RE: 7-ZN-2016#2
Palmeraie Phase II

The Planning & Development Services Division has completed the review of the above referenced development application submitted on 5/11/2020. The following **2nd Review Comments** represent the review performed by our team, and is intended to provide you with guidance for compliance with city codes, policies, and guidelines related to this application.

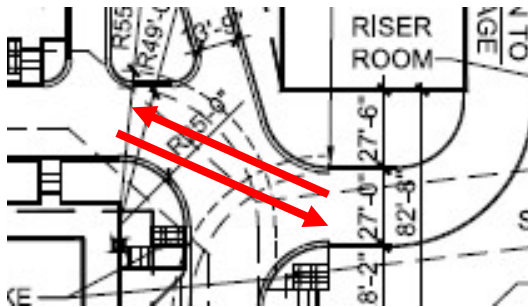
17. The second submittal of the project plans did not address Comments #18, #19 and #20 from the 1st Review Comment Letter. Please provide additional plans and diagrams to demonstrate compliance with the comments outlined in Comments #18, #19 and #20 of the 1st Review Comment Letter. (Zoning Ordinance, Sec. 1.305.)
18. Please update the project plans to provide a minimum 6-foot-wide accessible pedestrian route from the ground floor retail of Building T of the development to each abutting public/private street that provides a pedestrian sidewalk/multi-use trail. (DSPM, Sec. 2-1.310)

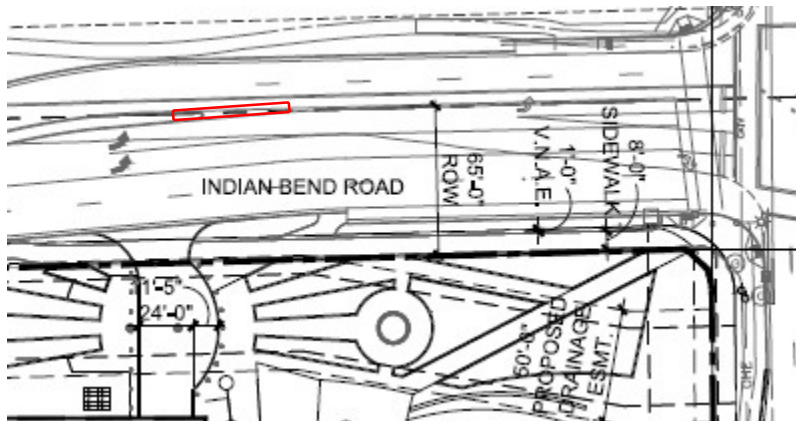
22. The raised median in Indian Bend needs to be extended further east to prevent drivers from making left-turns into the site driveway.

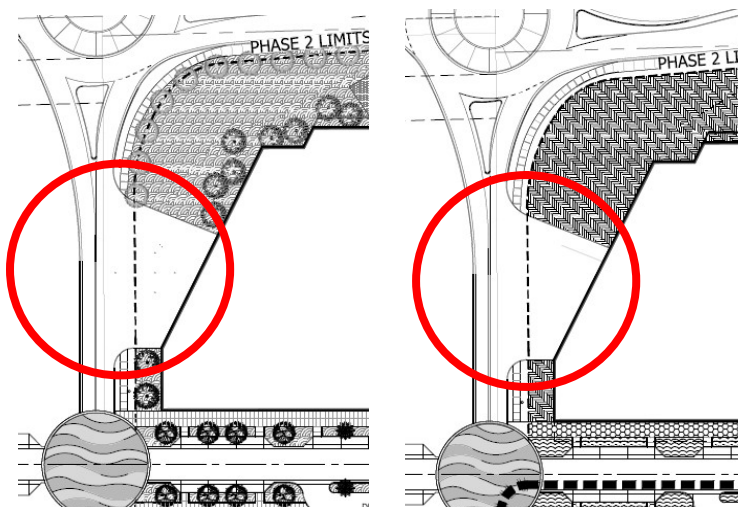
23. This service area needs to have limited access. Vehicles will not be allowed to make left-turns this close to the roundabout. How does the sidewalk continue across this entry? This needs a lot of work to make it function appropriately.
